PCN – Process Change Notification

Change:	AA.107.301111
Date:	2017/03/08
Author	Haley Tsai

Model#	Part Number	Changes
AA.107 - Stingray Adhesive Mount - GPS/GLONASS 3000mm RG174 SMA(M)ST	AA.107.301111	<ol style="list-style-type: none"> 1. Add WEEE Heatshrink Tube 2. Amend Label Orientation 3. Amend Housing Dimension 4. Amend Housing Material 5. Amend dimensions between two labels

Illustration of Change

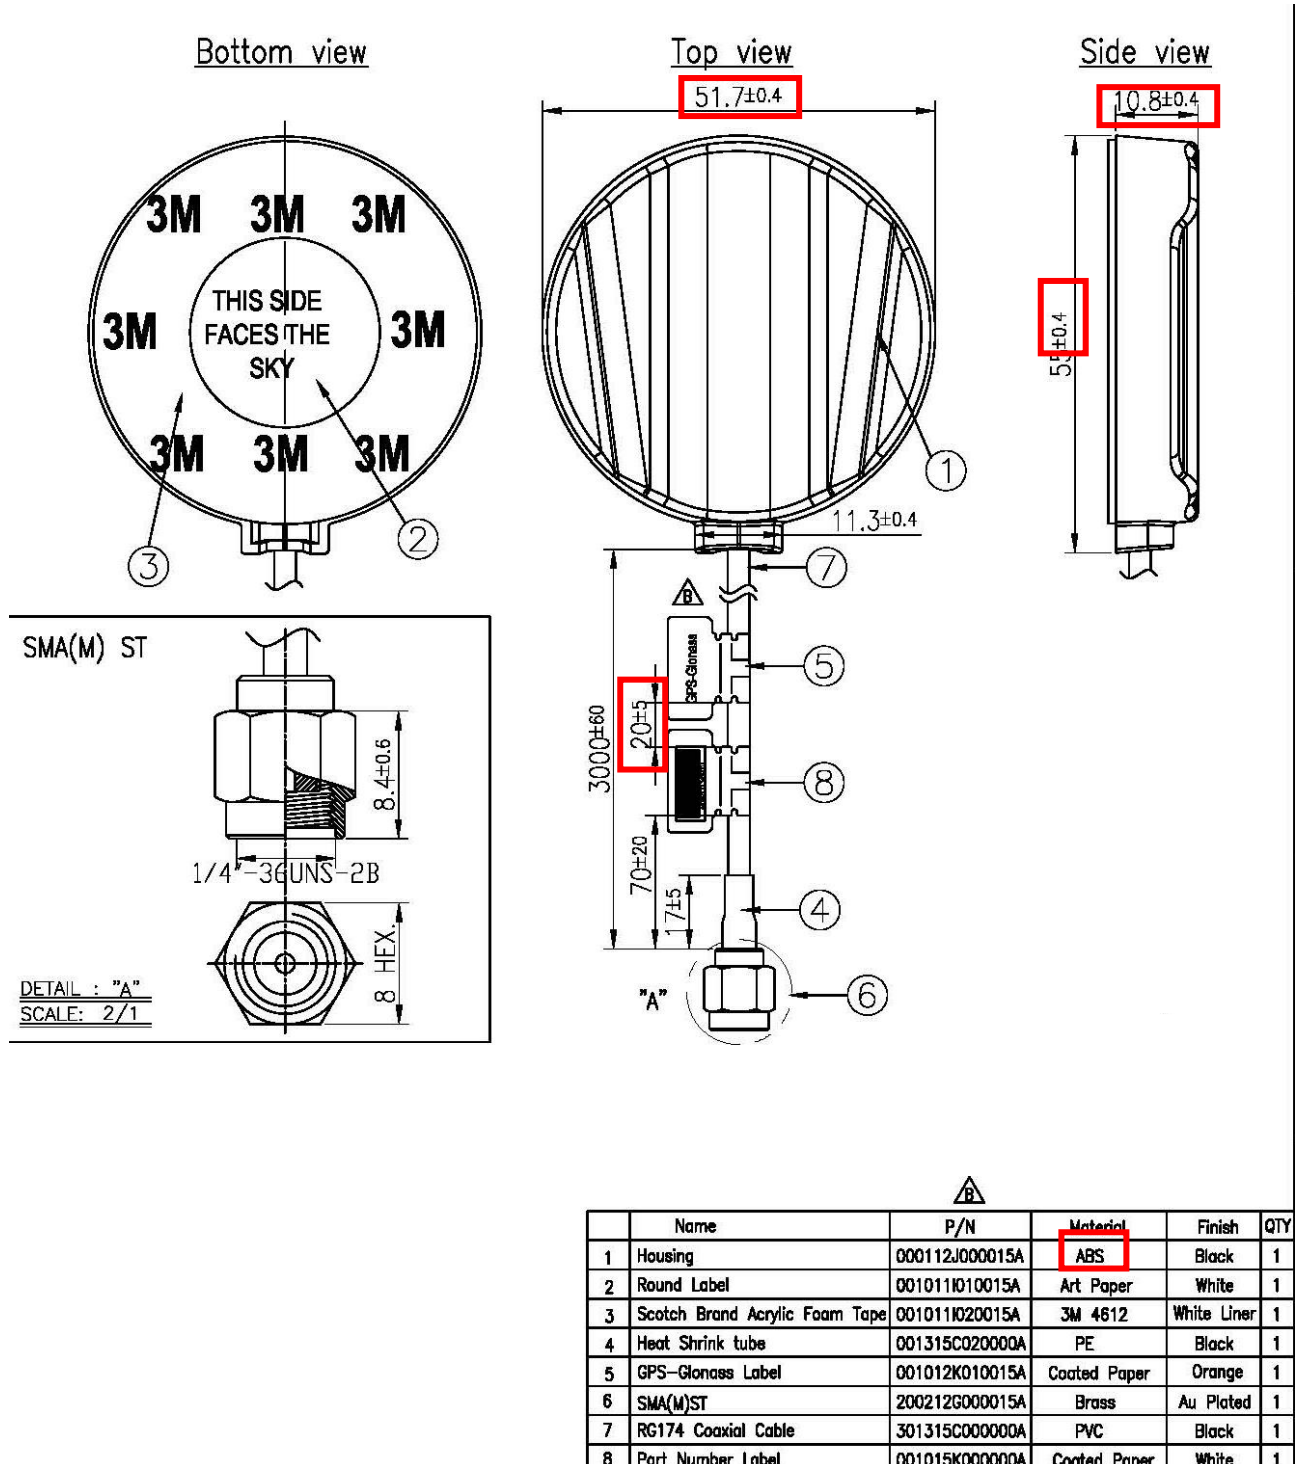
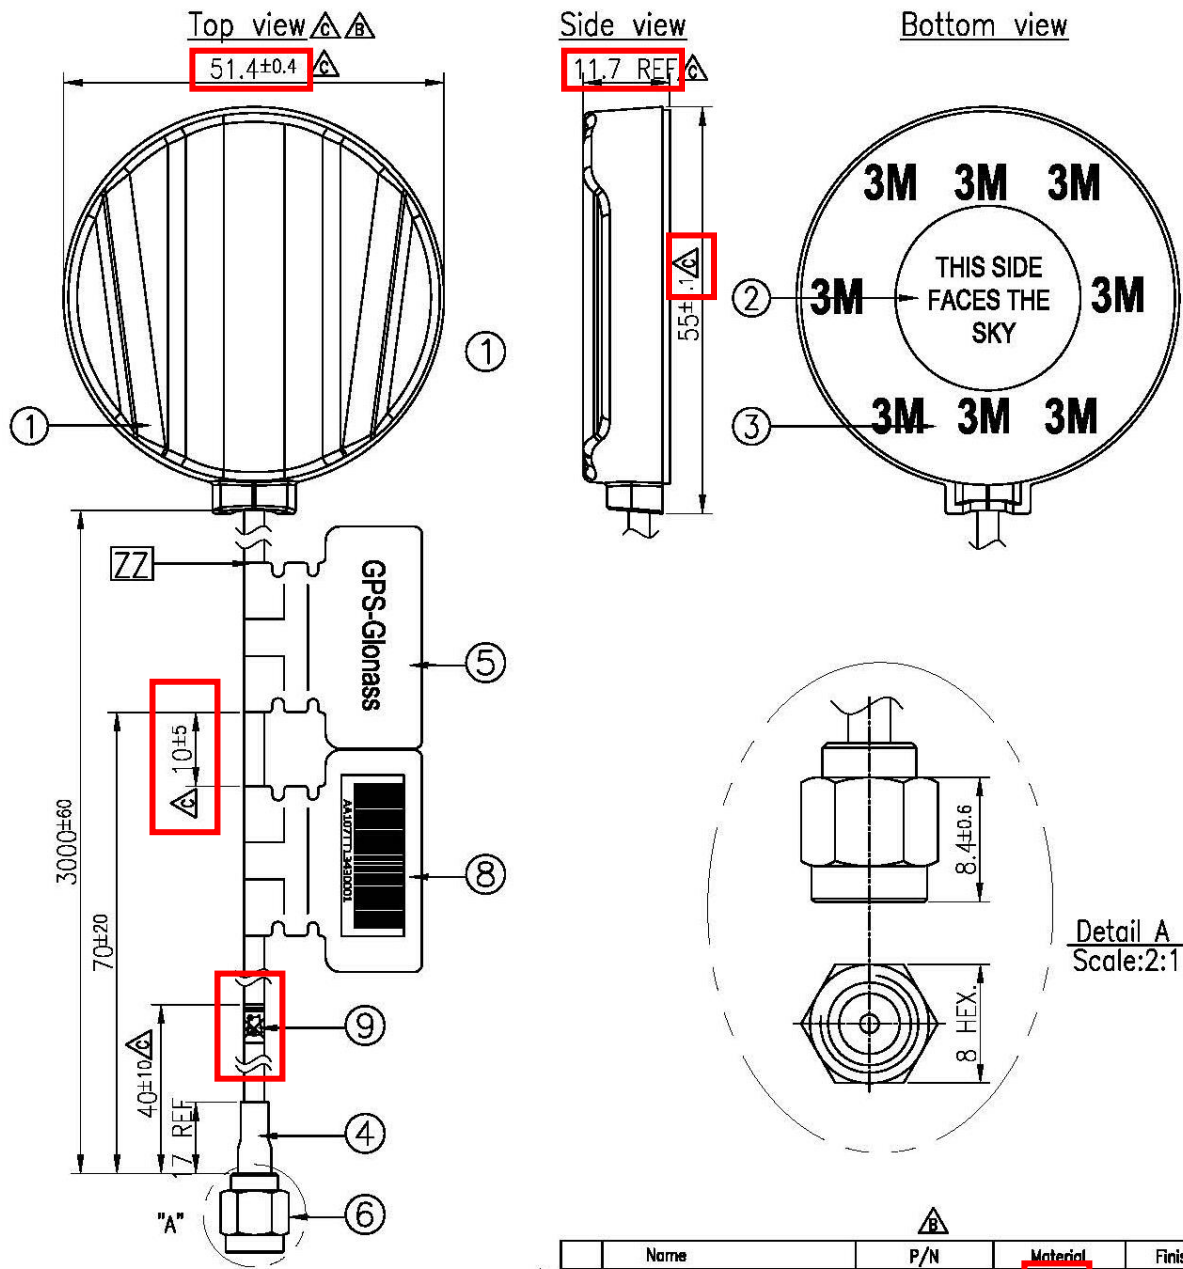
1. Add WEEE heatshrink tube.
2. Amend label orientation.
3. Amend housing dimension from 51.7mm to 51.4mm.
4. Amend housing dimension from 10.8mm to 11.7mm.
5. Amend housing tolerance from 0.3mm to 1.0mm.
6. Amend Housing Material from ABS to PC.
7. Amend dimensions between two labels from 20mm to 10mm.
